UNITED STATES PATENT AND TRADEMARK OFFICE

APPLICATION NO.	FILING DATE	FIRST NAMED INVENTOR	ATTORNEY DOCKET NO.	CONFIRMATION NO.
10/776,061	02/11/2004	Manish Sharma	200310026-1	2092

Office Action Summary

DETAILED ACTION

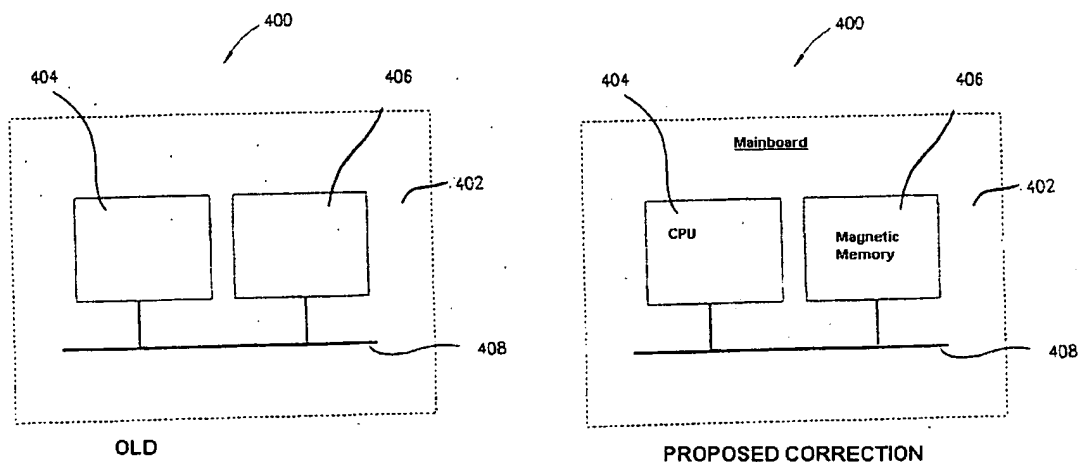
6. The drawings are objected to because the unlabeled rectangular box(es) shown in the drawings (Fig. 4) should be provided with descriptive text labels. For clarity purposes, Examiner suggests the following proposed correction for Figure 4:

Corrected drawing sheets in compliance with 37 CFR 1.121(d) are required in reply to the Office action to avoid abandonment of the application. Any amended replacement drawing sheet should include all of the figures appearing on the immediate prior version of the sheet, even if only one figure is being amended. The figure or figure number of an amended drawing should not be labeled as "amended." If a drawing figure is to be canceled, the appropriate figure must be removed from the replacement sheet, and where necessary, the remaining figures must be renumbered and appropriate changes made to the brief description of the several views of the drawings for consistency. Additional replacement sheets may be necessary to show the renumbering of the remaining figures. Each drawing sheet submitted after the filing date of an application must be labeled in the top margin as either "Replacement Sheet" or "New Sheet" pursuant to 37 CFR 1.121(d). If the changes are not accepted by the examiner, the applicant will be notified and informed of any required corrective action in the next Office action. The objection to the drawings will not be held in abeyance.
